LP outside cooktop connection <u>Description</u>

It has been decided on certain 2021 Mallard, 2020-2021 North Trail, 2021 Trail Runner, & 2020-2021 Wilderness travel trailers the outside cooktop LP connection could be loose. This could lead to an increased risk of injury, fire, and/or damage to property

RECALL SERVICE BULLETIN

Cooktop

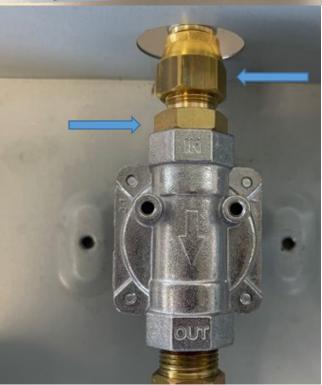
Remove the screws from the top of cooktop using a screw driver.

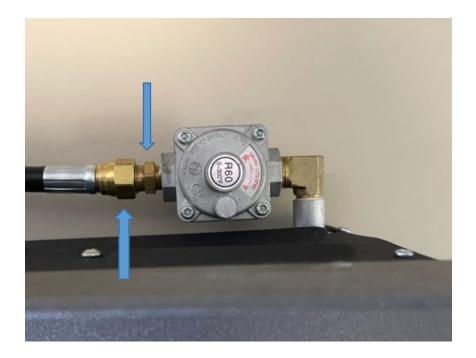
Remove the screws from the shield using a screw driver.

Use a ¾" and 5/8" wrench to tighten the LP connection.
